PARTS & SERVICE NEWS

REF NO.	AA01144		
DATE	July 11, 2001

SUBJECT: REPAIR OF WORK EQUIPMENT CONTROL LEVER LINKAGE RODS TO

APPLICATION: GD555-3C Motor Grader, S/N 50002 and up

3. Contents of the improvement

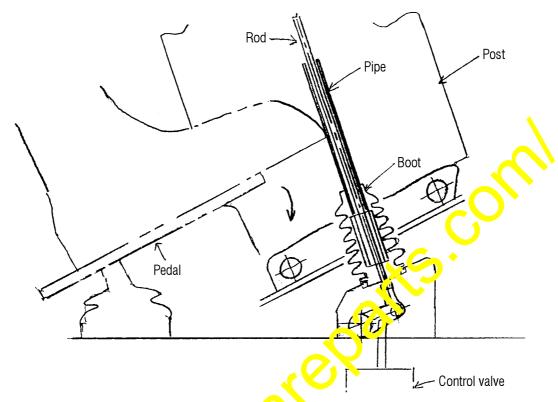
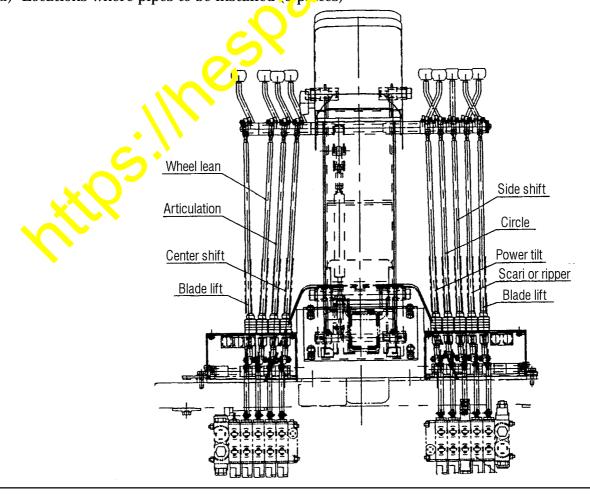
Since there have been cases, with the above motor graders when an operator depressed the brake pedal, where the tiptoe of the operator's boot touched the articulation control lever linkage rod with such strength as to activate articulation, carry over the work equipment control lever linkage rods thereby to prevent the rods from being caught by operator's boots.

(1) The work equipment control lever linkage rod is to be inserted through a pipe to prevent the rod from being forced to move when the brake pedal is depressed.
